Mooney Mite Series M-13
Service Bulletin No. 14

MOONEY AIRCRAFT, INC.
M-18 SERVICE LETTER NO. 15

M-18 SERVICE LETTER NO. 16

M-18 SERVICE LETTER NO. (17)

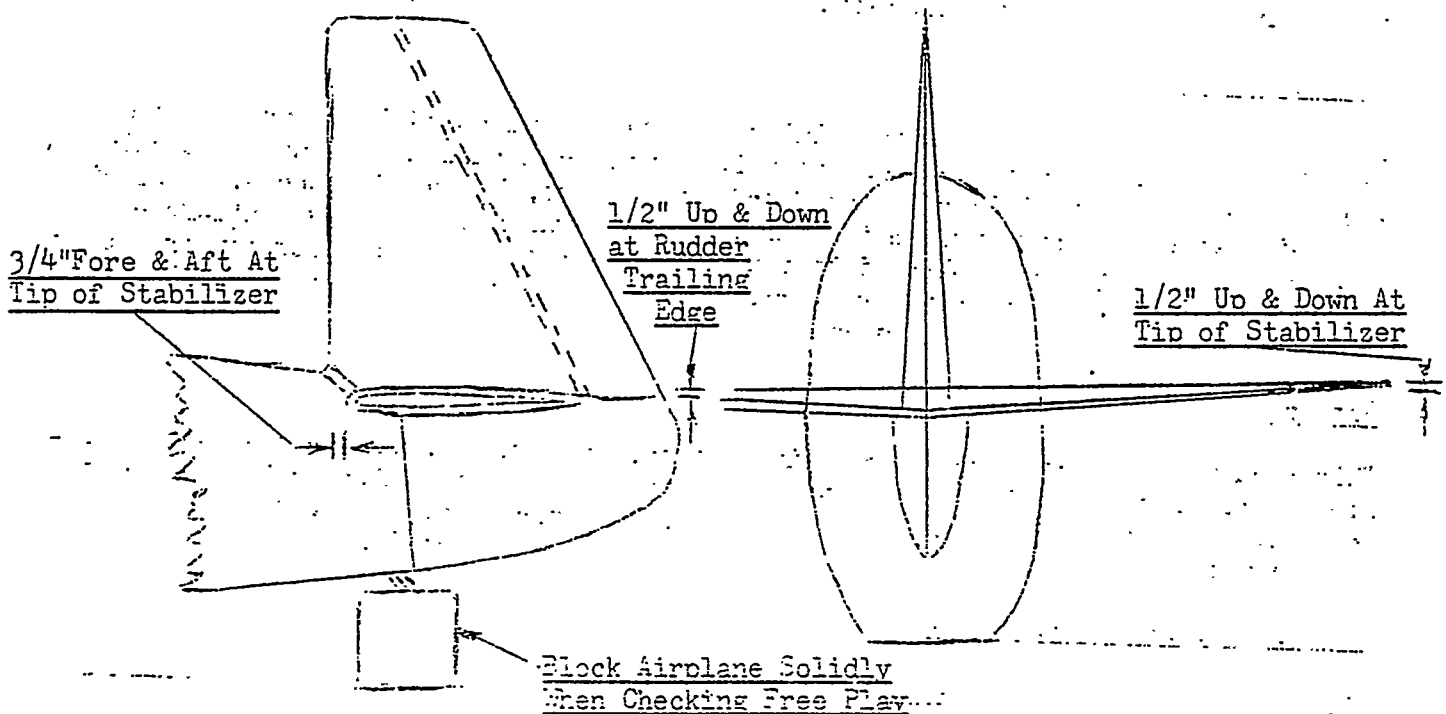
The following sketch illustrates the maximum allowable free play at the specified points.

When checking stabilizer tip free play, either fore and aft or up and down, measure free play on the opposite tip from where the stabilizer is moved by application of hand pressure. This eliminates errors in measuring due to bending deflections of the stabilizer itself.

Sketch A

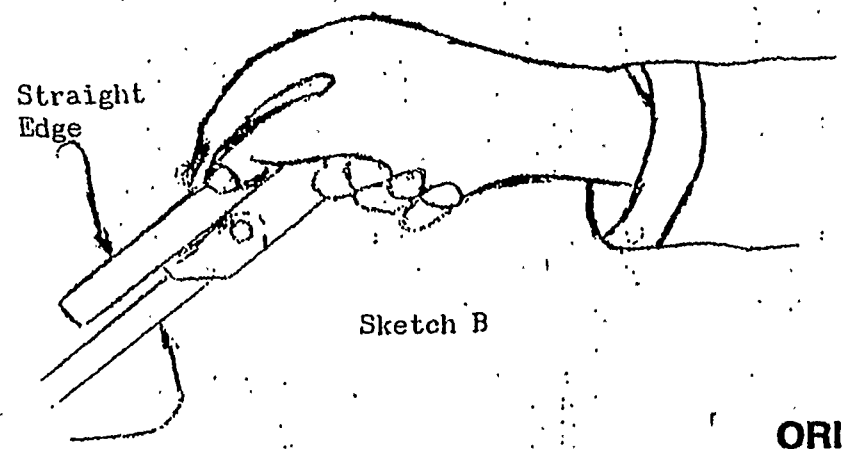
Elevate the aircraft on three suitable saw-horses. Two of which are placed under the wing just outboard of each main gear, between the third and fourth ribs, approximately three feet from the fuselage skin. The saw-horses should be of sufficient length to extend from slightly behind the rear spar to the front spar, and preferably past the leading edge of the wing. This length is desired to minimize damage to flaps and skin on the leading edge should the aircraft accidentally be rolled back or forward on the front spar while elevated on the horses. Should the tail be pushed down too far, a saw-horse extended behind the rear spar would rupture the flap fabric. Should the nose drop, rolling the aircraft onto the leading edge, the end of a saw-horse that did not extend beyond the spar would be pushed thru the leading edge skin. See Sketch A for elevation details.

Sketch B

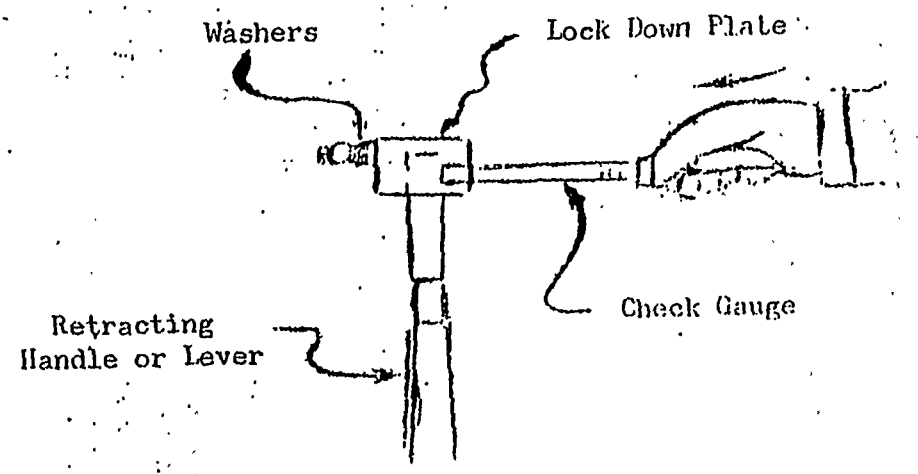
It has been found absolutely necessary for the over-center locks to be in the over-center position and that considerable force is required to change this position. To check whether lock is over center lay a short straight edge along the top side of the lock as shown in Sketch B.

Figure 1

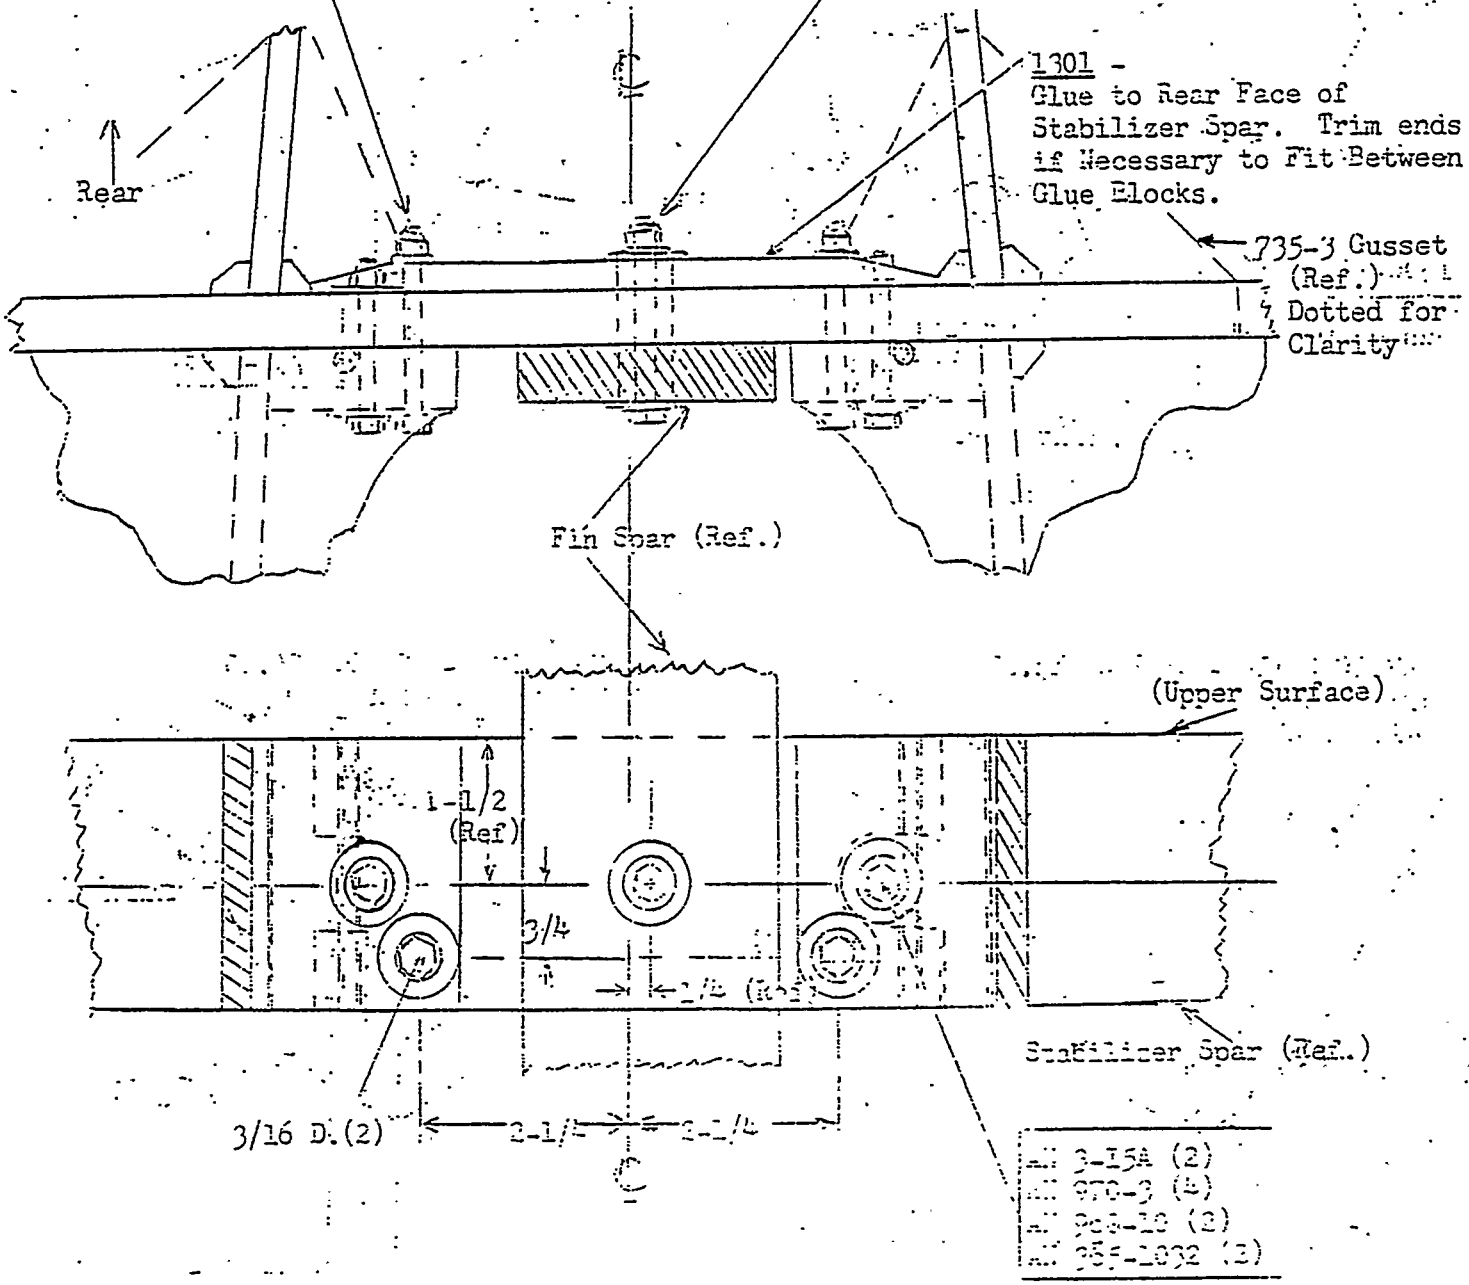
5. Any defective wood parts shall be replaced or repaired in accordance with Civil Aeronautics Manual 18 and/or manufacturers recommendations. When it is determined that the fin and horizontal stabilizer are in satisfactory condition, the rework shown in Figures 1 and 2 shall be accomplished. The glue used shall be a urea-formaldehyde type such as Melwood or Cascamite. Parts for the required rework are available at no cost. Order Kit 5118-16 from the Spare Parts Department of Mooney Aircraft, Inc.

1301 -
Glue to Rear Face of Stabilizer Spar. Trim ends if Necessary to Fit Between Glue Elocks.

Figure 3

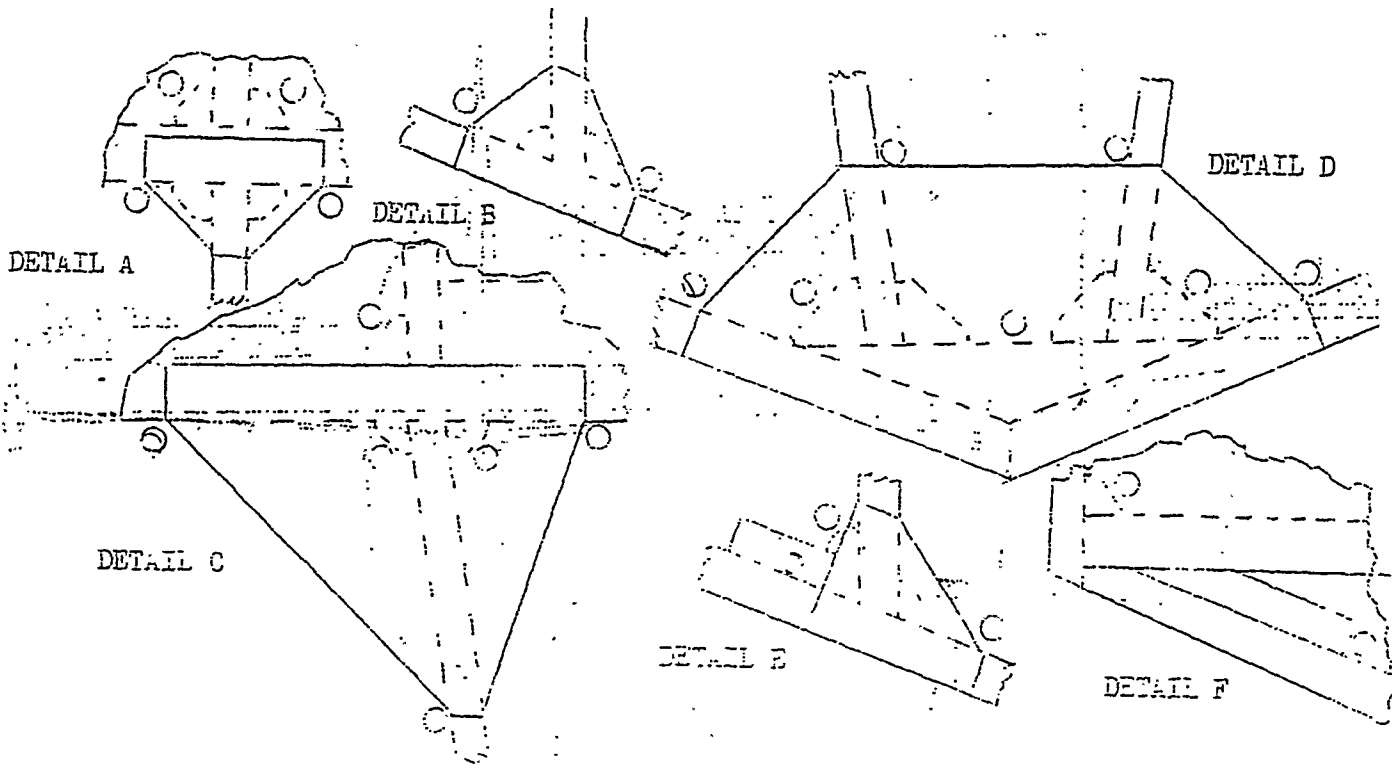
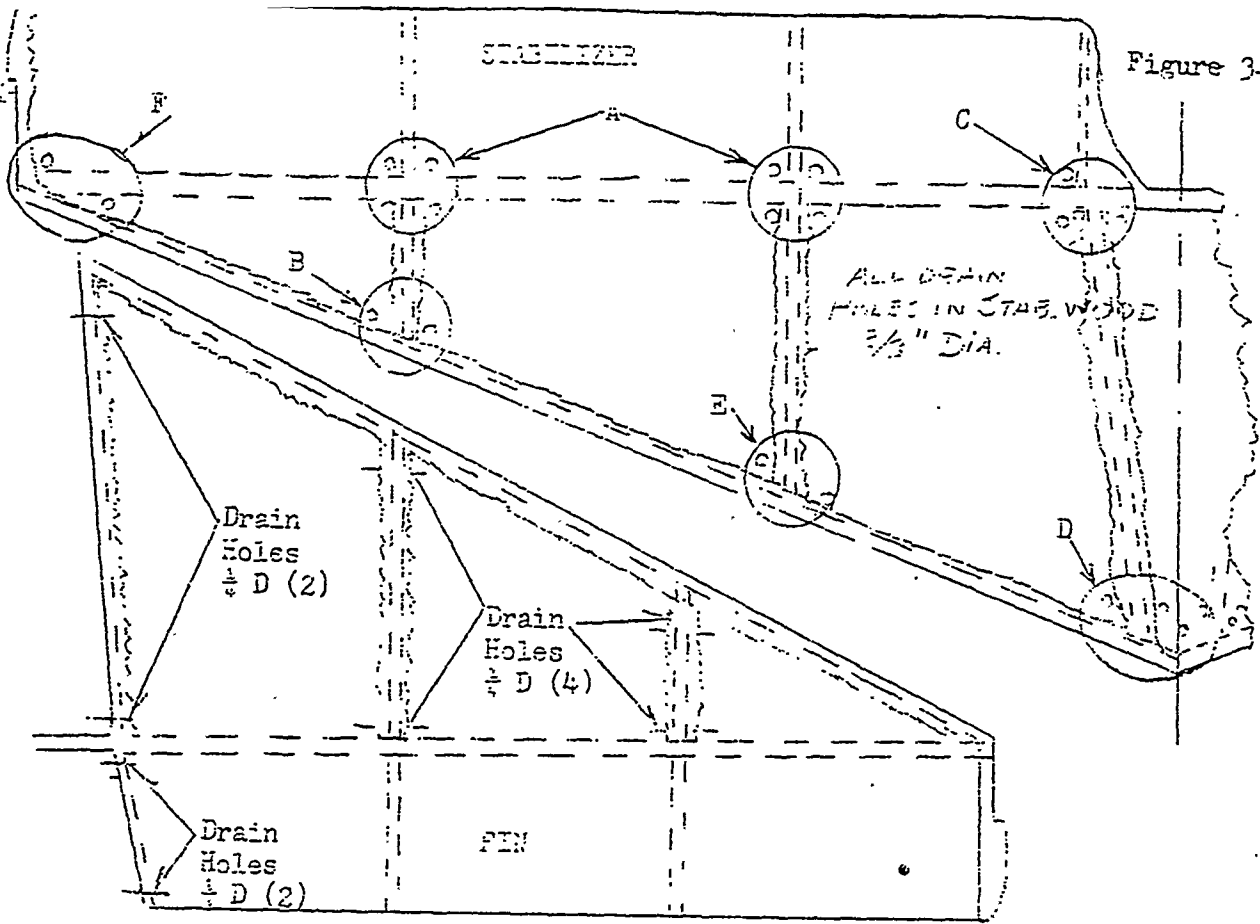
6. When recovering make fabric continuous under four outboard hinges on horizontal stabilizer and two upper hinges on fin. See that all drain holes are located as shown in Figure 3 and that they are clear.

- 1) Use all 331-B Grommets on Fabric over all drain holes in Stabilizer and Pin Body Kit.
- 2) Drill Pin Inlets in Ribs and clear hole in Body Kit after Fabric Installation.
- 3) Exercise care in drilling Drain Holes so as not to damage adjacent structure.

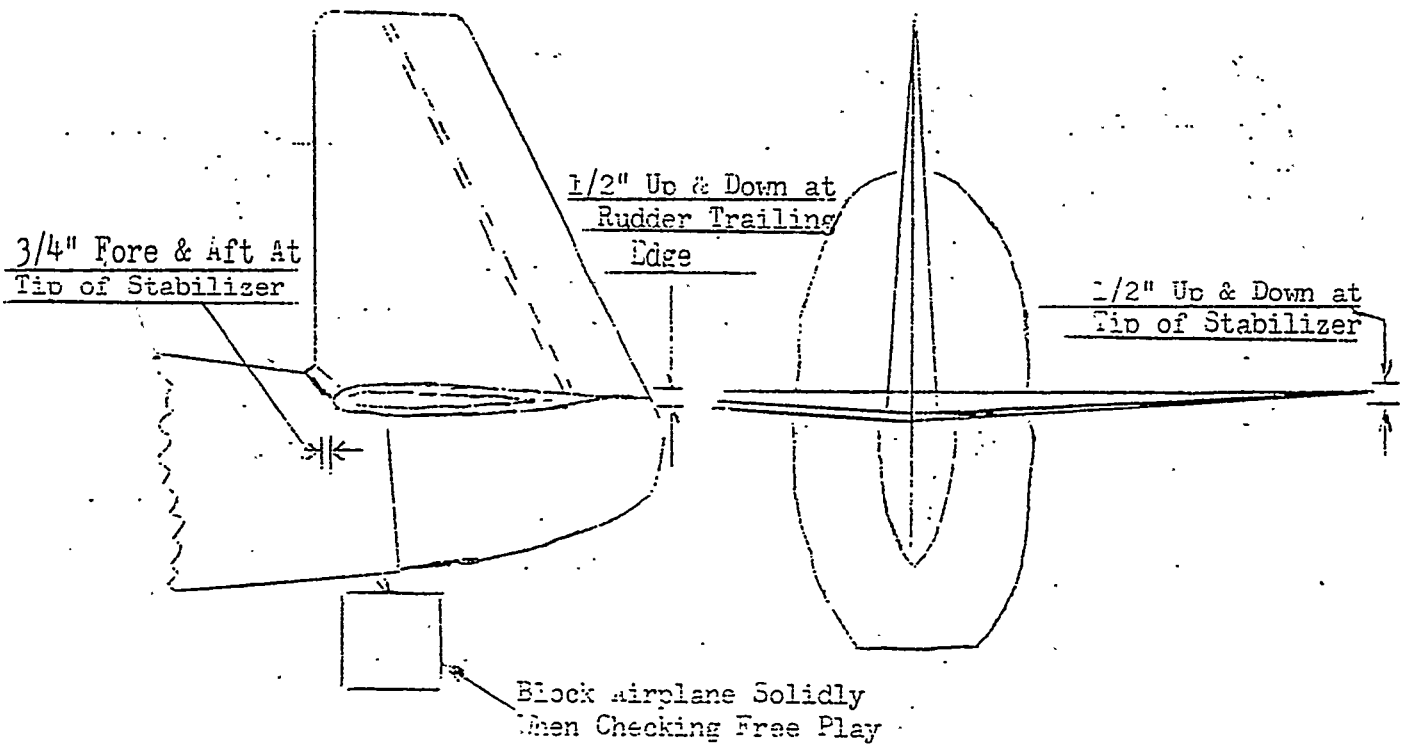
9. Reassemble and install empennage making sure all bolts are tight. Block airplane solidly at tail skid and inspect for empennage play as follows: (See Figure 4)

- (a) Horizontal stabilizer - move up and down at one tip and measure at opposite tip - total allowable play 1/2 inch up and down
 - (b) Horizontal stabilizer - move fore and aft at one tip and measure at opposite tip - total allowable play 3/4 inch fore and aft

- (c) Fin - move fore and aft at top of leading edge and measure at bottom of rudder trailing edge - total allowable play 1/2 inch up and down

Figure 5

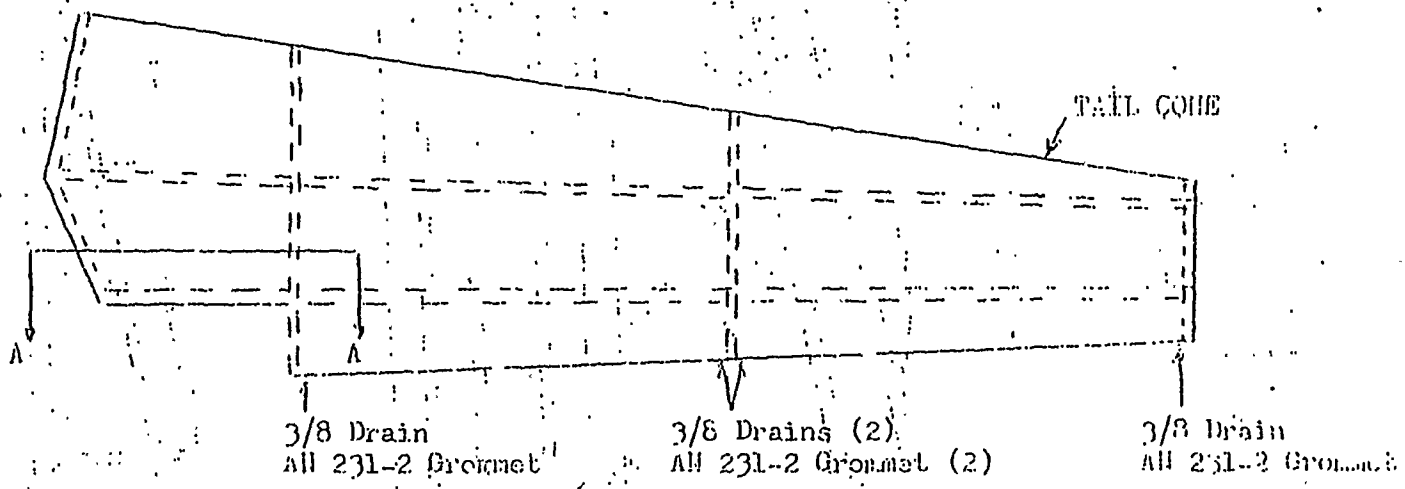
1. Inspect around steel fuselage fittings and drain holes for wood deterioration. See that all drain holes are located as shown in Figure 5 and that they are clear. Inspect all glue joints for deterioration.

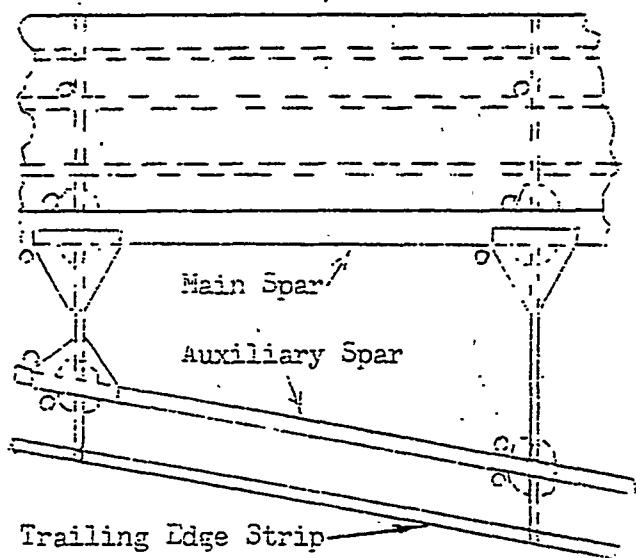
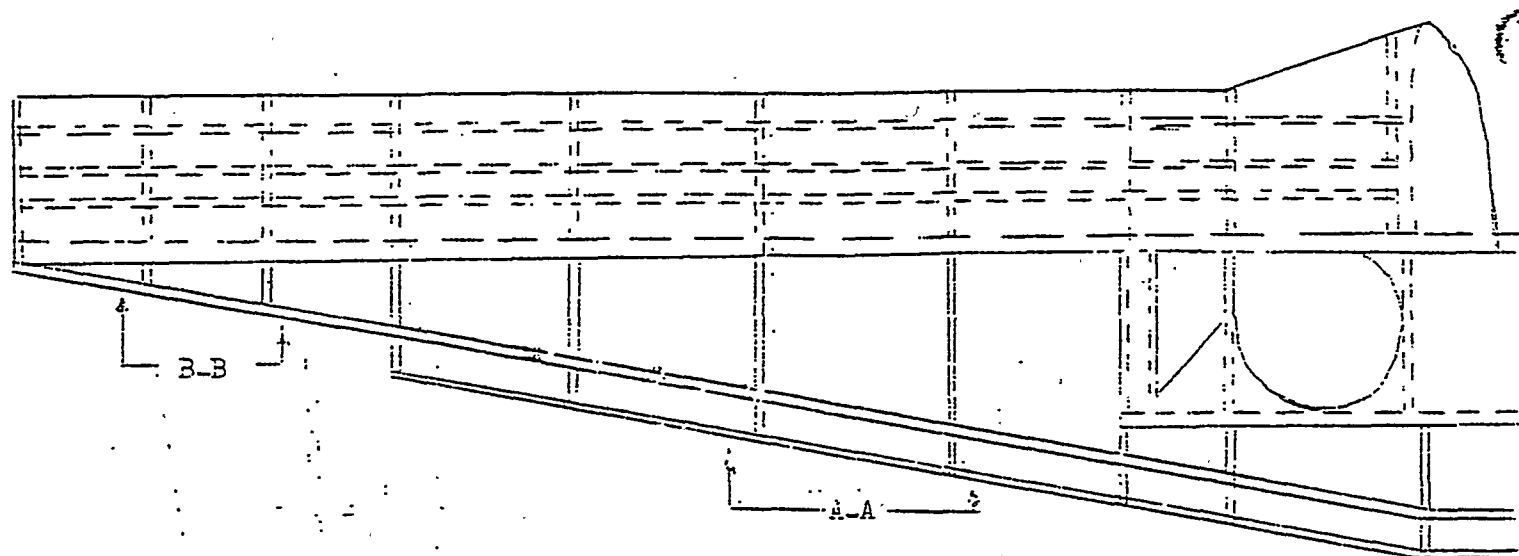
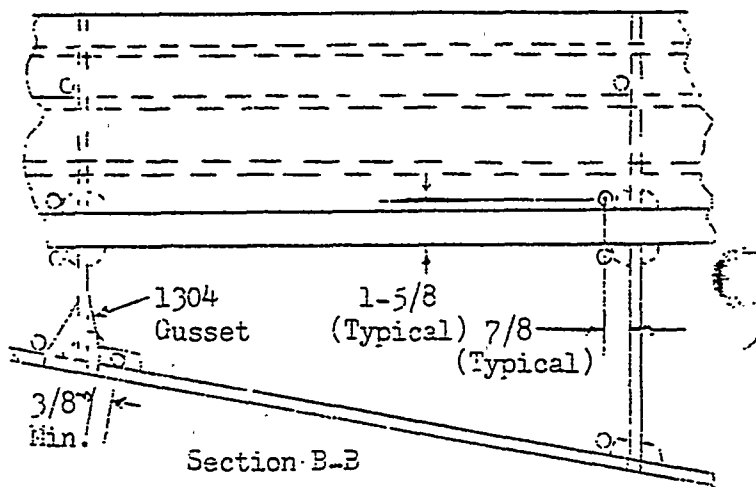
6. See that all drain holes are located as shown in Figure 6 and that they are clear.
7. Add a strip of water resistant cloth or plastic adhesive tape at the wing to fuselage joint (both sides) from the wing leading edge to the wing trailing edge under the metal fairing strip on both sides of the airplane. This tape strip should form an angle with one leg attached to the fuselage and one to the wing in order to prevent the entry of water at this point.

- 1) Use All 231-1 Grommets over all Drain Holes - All Drain Holes $3/8$ diameter.
- 2) If Aileron Hinge Attachment is found loose, it is recommended that Gusset P/N 1304 be installed top and bottom at Station 148 from auxiliary Spar to Trailing Edge Rib. Distance from center of Aileron Hinge Mount Hole to Gusset no less than $3/8$ inch.
- 3) Exercise care in drilling Drain holes so as not to damage adjacent structure.
